April 10, 2026

**Re: Hillcrest Subdivision – Phase 9 ([PR#58-2026](#))
McMinnville Water & Light ([PWS ID#00497](#))
Conditional Approval**

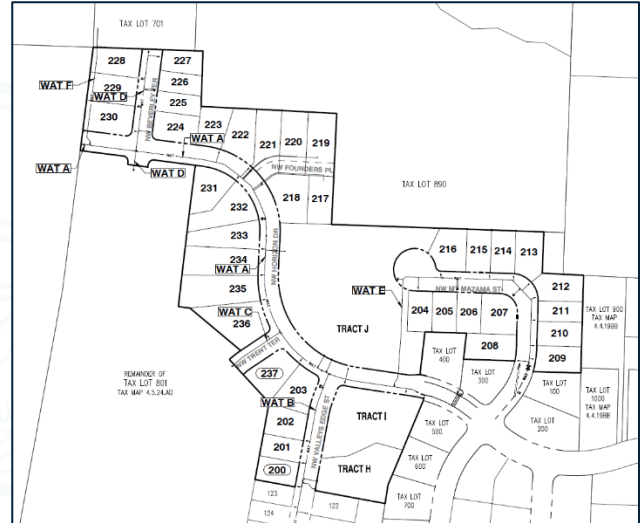
Phase 9 (originally referred to as Phase 3 in the LUCS documents) is in the northwest corner of the development and consists of 37 lots as follows:

- **Lots 200-203:** 224-LF of 8" dia. cement-mortar lined ductile iron water main to serve 4 lots (lots 200-203) along NW Valley's Edge St. (Water B alignment Table)
- **Lots 204-216:** 760-LF of 8" dia. cement-mortar lined ductile iron water main to serve 13 lots (lots 204-216) along NW Mt. Mazama St. (Water E alignment Table)
- **Lots 224-230:** 282-LF of 8" dia. cement-mortar lined ductile iron water main to serve 7 lots (lots 224-230) along NW Beverley Terrace (Water F & D alignment Tables).
- **Lots 217-223 & 231-236:** 1,286-LF of 8" dia. cement-mortar lined ductile iron water main to serve 13 lots (lots 217-223 & 231-236) along NW Horizon Drive, NW Founders Place, and NW Trent Terrace (Water A & C alignment Tables).

1. All items in contact with potable water must meet NSF Standard 61 or equivalent.
2. The design must allow for 20 psi to be maintained at all service meters.
3. Air-relief valves, if needed, must be installed at high points where air can accumulate. The breather tube on air-relief valves must be extended above ground surface and provided with a screened, downward facing elbow.
4. Water and sewer line crossings conform to OAR 333-061-0050(9) as noted in Water Construction Note #9 on Sheet C-400.
5. Disinfection of the waterline must be completed according to AWWA C651. Results from the coliform sampling must be provided to our office.
